**THE REGIONAL MUNICIPALITY OF YORK
Request for Tender No. T-19-349 Addendum#2**

For: Interior Renovation – 3rd Floor Block A, B, & D at the York Region Administrative Centre

ADDENDUM NO.: E-02

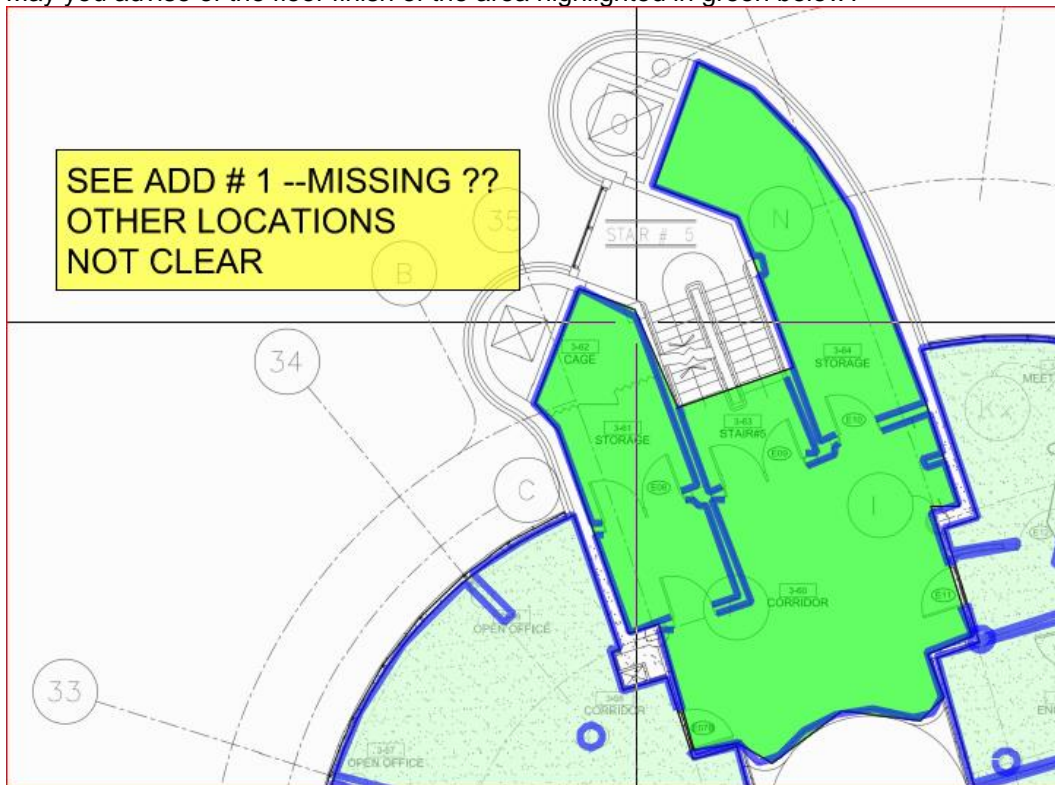
Q1. May you advise of the floor finish of the area highlighted in green below?

- A1. Existing floor finish to remain in the following rooms: 3-62 Cage, Storage 3-61, Stairs 3-63, and Storage 3-64. New carpet CP-1 in Corridor 3-60 and room between Corridor 3-60 and Storage Room 3-61.**
